GNRO-2010-00010

SUBJECT: Responses to NRC Requests for Additional Information Pertaining to License Amendment Request for Power Range Neutron Monitoring System (TAC No. ME2531)

Grand Gulf Nuclear Station, Unit 1
Docket No. 50-416
License No. NPF-29

**RESPONSES TO NRC REQUESTS FOR ADDITIONAL INFORMATION
PERTAINING TO LICENSE AMENDMENT REQUEST
POWER RANGE NEUTRON MONITORING SYSTEM UPGRADE**

Table 3.3.1.1-1 (page 1 of 3)
Reactor Protection System Instrumentation

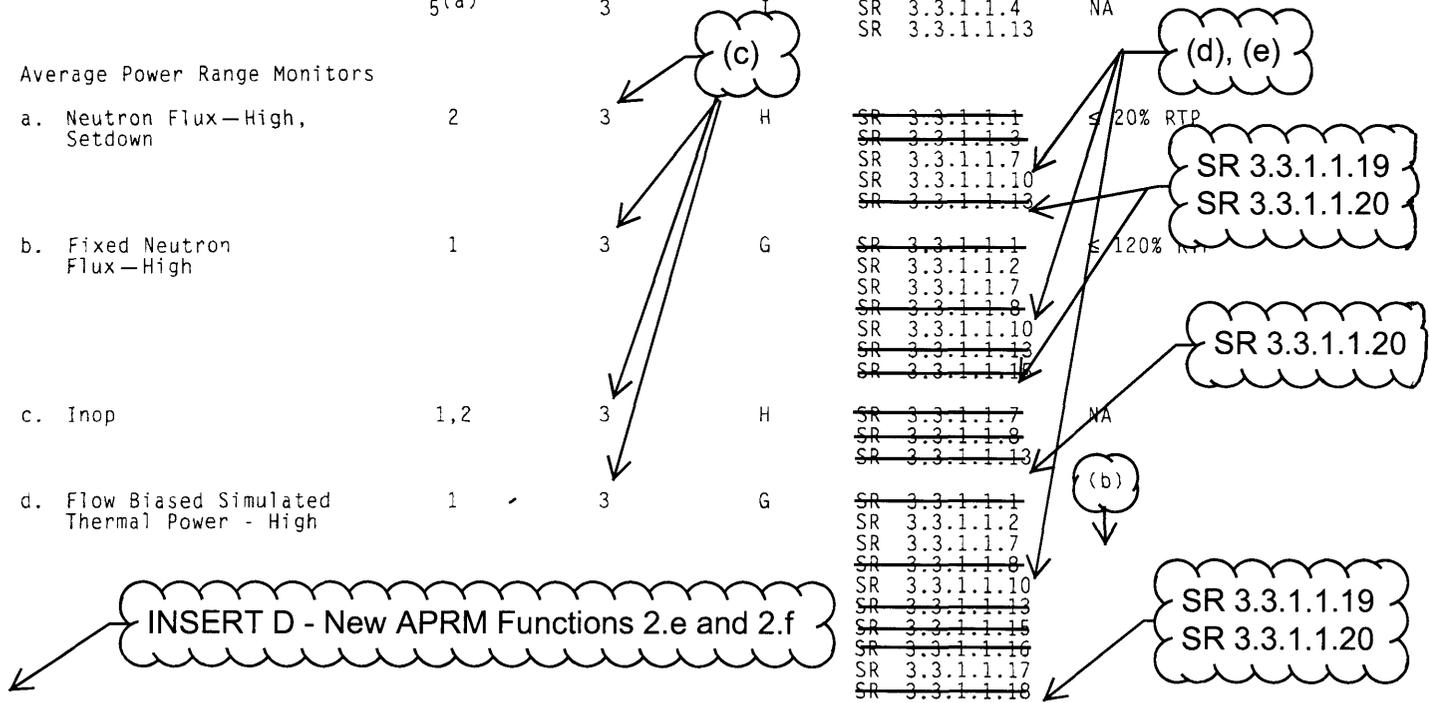
In addition to the changes pertaining to the NRC RAIs, Entergy discovered a typographical error in marked-up TS Table 3.3.1.1-1, provided on page 13 of Attachment 3 of Reference 1. The reference for Note (b) was inadvertently shown as being deleted. As discussed in Section 4.4.3.5.a of Reference 1, Entergy proposed to relocate the reference to align with the applicable function in the table. A corrected marked-up TS Table 3.3.1.1-1 is provided in Attachment 2. Please replace the current TS Table 3.3.1.1-1 with the corrected table.

Please state which SRs verify trip setpoint settings for functions 2.a, 2.b, 2.c, 2.d, 2.e, and 2.f in TS Table 3.3.1.1-1, and provide a revised TS Table 3.3.1.1-1 with the addition of notes (d) and (e) for these functions as needed.

At GGNS, trip setpoints are typically verified via channel calibration procedures, only. APRM Functions 2.a, 2.b, 2.d, and 2.f will follow this practice with their trip setpoints being verified via channel calibration SR 3.3.1.1.10, only. The proposed Notes (d) and (e) have been applied in TS Table 3.3.1.1 to SR 3.3.1.1.10 for these functions, as discussed in Section 4.4.3.1 of the LAR. Notes (d) and (e) are not applicable to APRM Functions 2.c and 2.e, as discussed in Section 5.1.5 of the LAR.
